# PROPOSED RESIDENTIAL DEVELOPMENT AT GWELLYN AVENUE, KINMEL BAY

## *Flood Consequences Assessment / Proposed Drainage Strategy*

Report Ref: BEK-RB20009-1  
September 2022 (Revised January 2024)

**DISCRETIONARY PLANNING ADVICE SERVICE REVIEW OF A FLOOD  
CONSEQUENCES ASSESSMENT (FCA) FOR PROPOSED RESIDENTIAL  
DEVELOPMENT FOR 83 DWELLINGS AT LAND OFF GWELLYN AVENUE, KINMEL  
BAY, RHYL, LL18 5HR**

**Figure 3-1: Increase in water levels due to site raising – 0.1% AEP 2120 CI2 Defended**

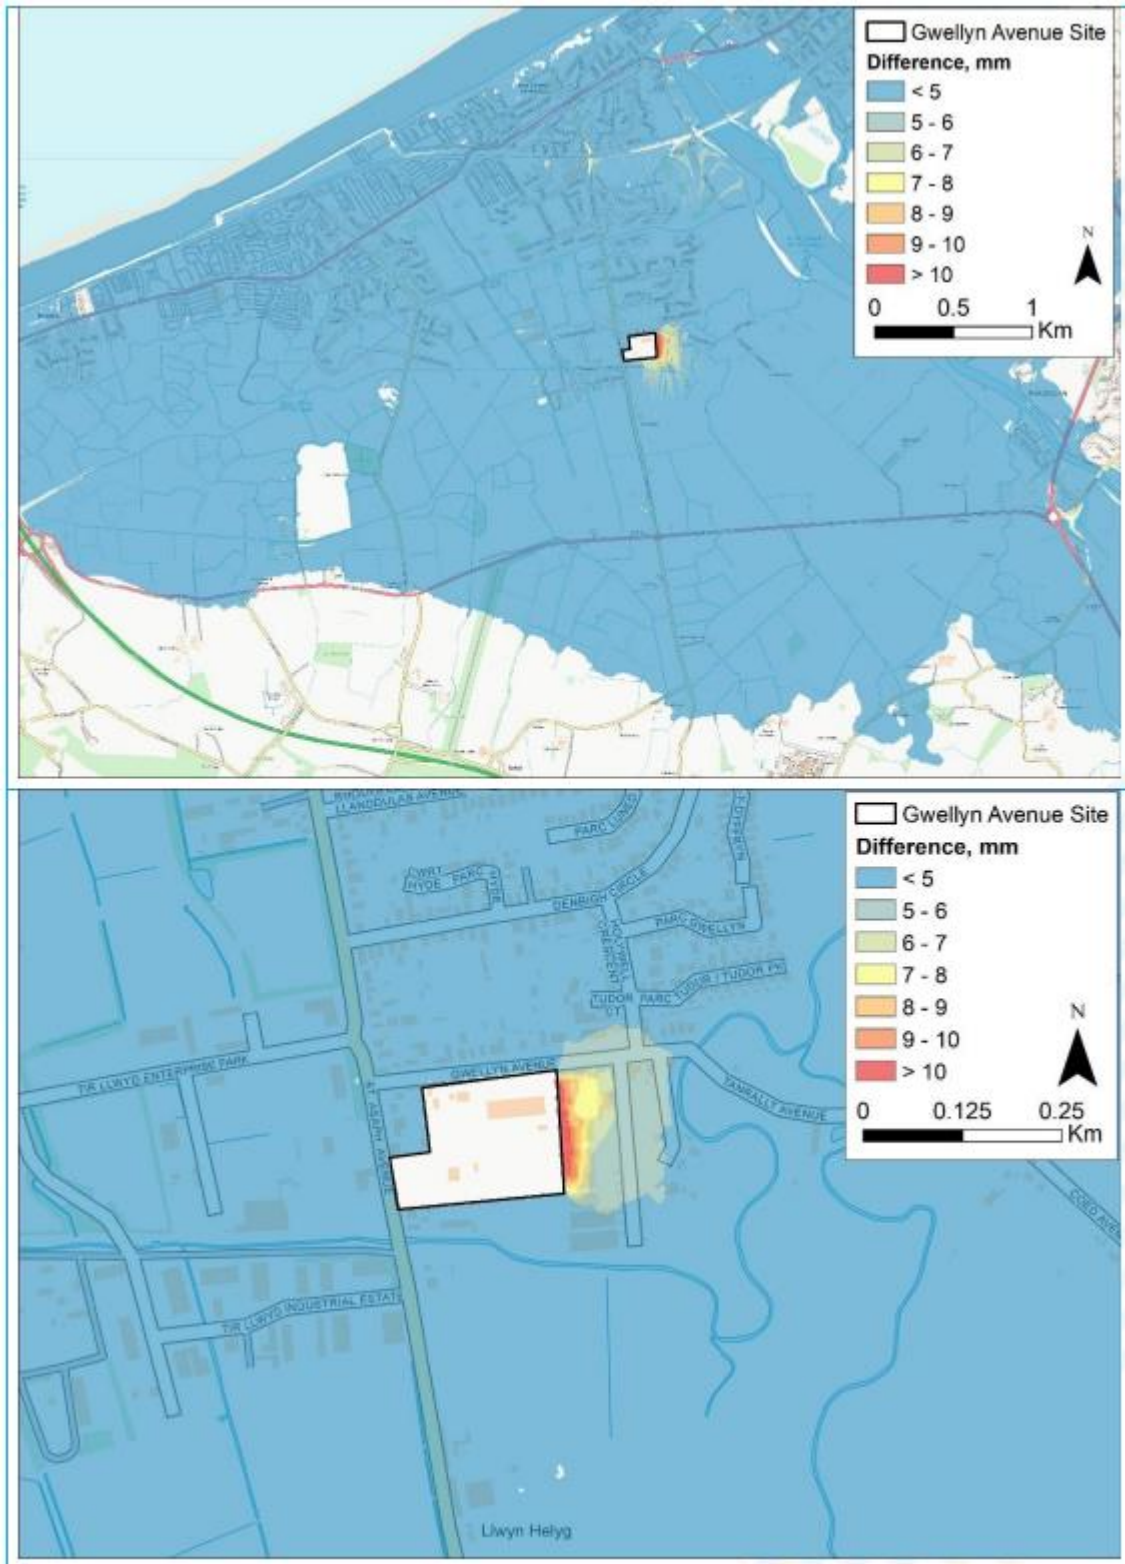
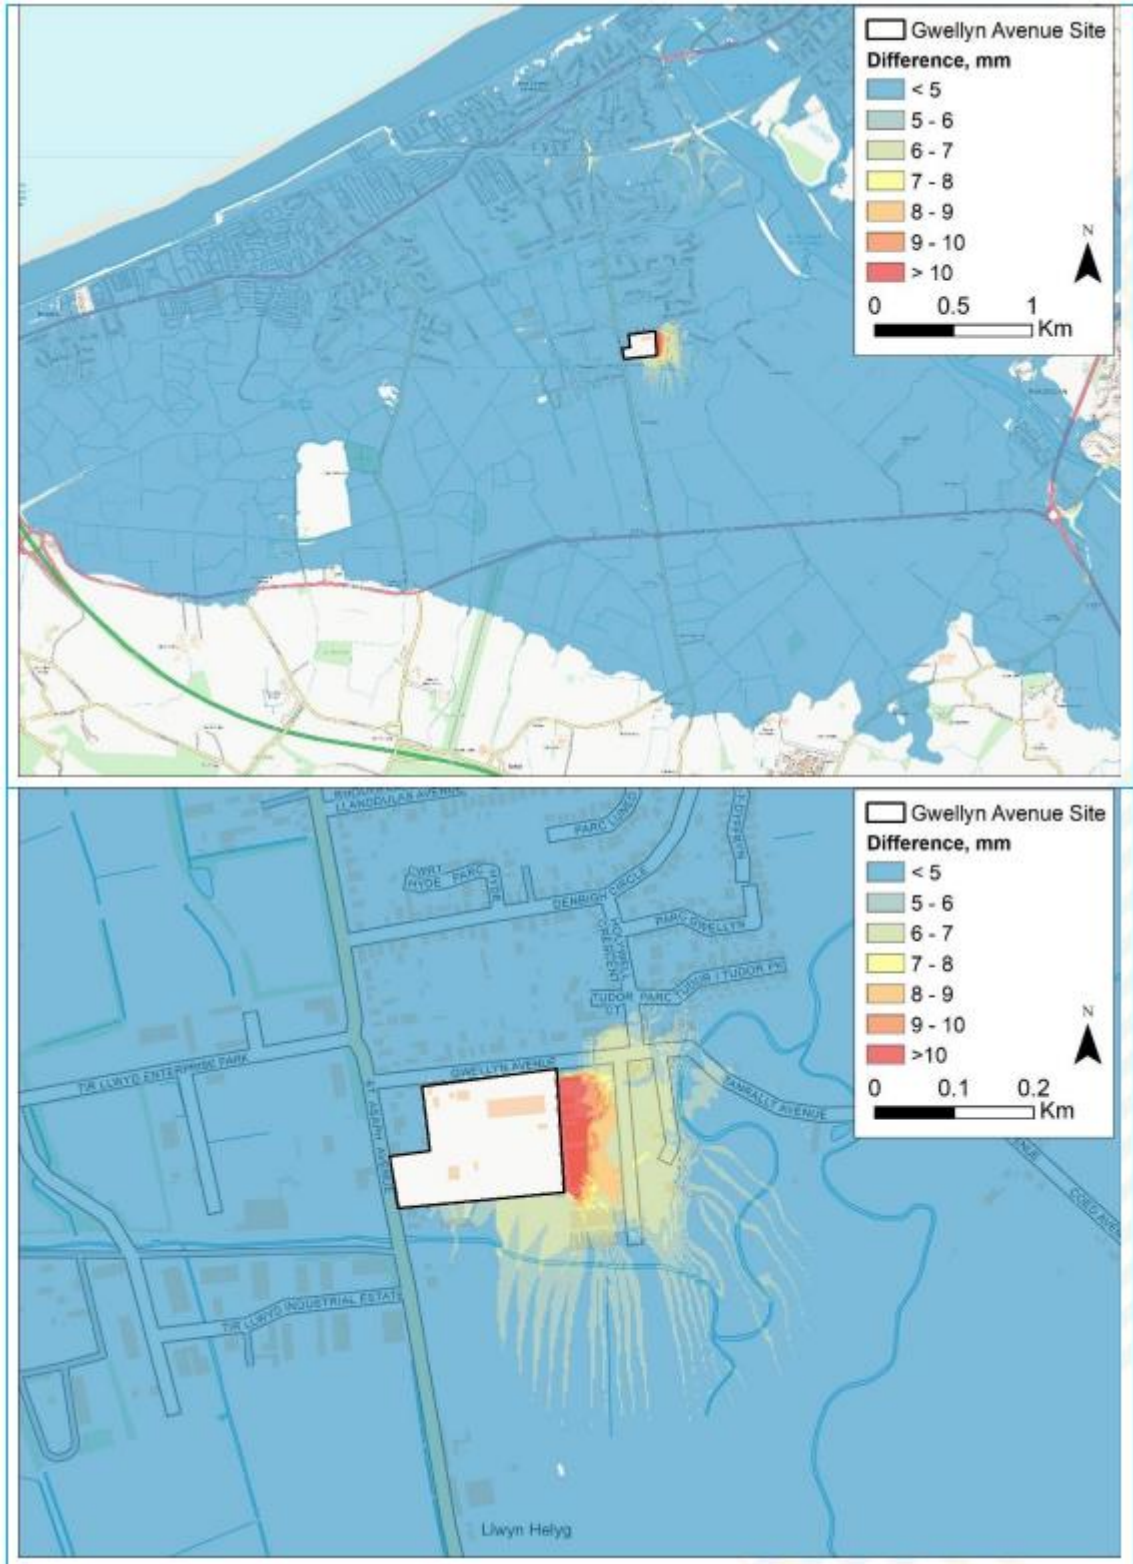
As required in A1.12 of TAN15, it should be demonstrated that the proposed development does not increase flood risk elsewhere. The effects of the reduction of existing flood storage volume and/or flood conveyance with the effects elsewhere must be quantified and appropriate compensatory storage provided to mitigate any increases and/or other negative impacts. To represent the proposed development, the site was raised to a level of 6.00 mAOD in the model resulting in increased levels adjacent to the site of over 10mm in places. The FCA fails to show that the impact of the development on flood risk elsewhere can be mitigated, and therefore does not demonstrate compliance with the requirements of A1.12 of TAN15.

The report states that 'In practice the embankment will be graded at a 1 in 3 slope and planted with trees and shrubs which is likely to reduce the increase in water level to below NRW's criteria of 5mm' but since this has not been modelled, there is no evidence that this criteria will be met. It also states that 'In practice, with a proposed FFL of 5.45m AOD, it will only be necessary to raise the general site level to approximately 5.3m AOD – to ensure that it remains flood free over the lifetime of the development. Although the effect of this level

In summary, the modelling shows that the land raising required to comply with A1.14 of TAN15 will unacceptably increase the risk of flooding elsewhere and we would raise concerns if consulted as part of a planning application. If the proposed site levels are expected to be lower than that currently modelled, we would expect evidence to be provided that quantifies the associated changes in flood risk. Consideration should be given to compensatory storage to mitigate any negative impacts which again should be quantified to prove changes to flood levels adjacent to the site are within tolerable limits.

4.9.3 A decision has been taken NOT to undertake the revised modelling until such time as the results of the Pre Application Consultation exercise are known. If these support the proposed development then it is likely that the model will be adjusted before any planning application is submitted. However NRW's concerns have been discussed with the Modellers (JBA) who have advised that the current resolution of the model (5m grid) may be contributing to the apparent increase in flood level on 3<sup>rd</sup> party land. Using a higher resolution grid of the site area from 5m down to 0.5m or possibly even 0.25m to give a better representation of the site and slope of the embankment would allow the topographical roughness to be altered and may reduce the effect on adjacent land.
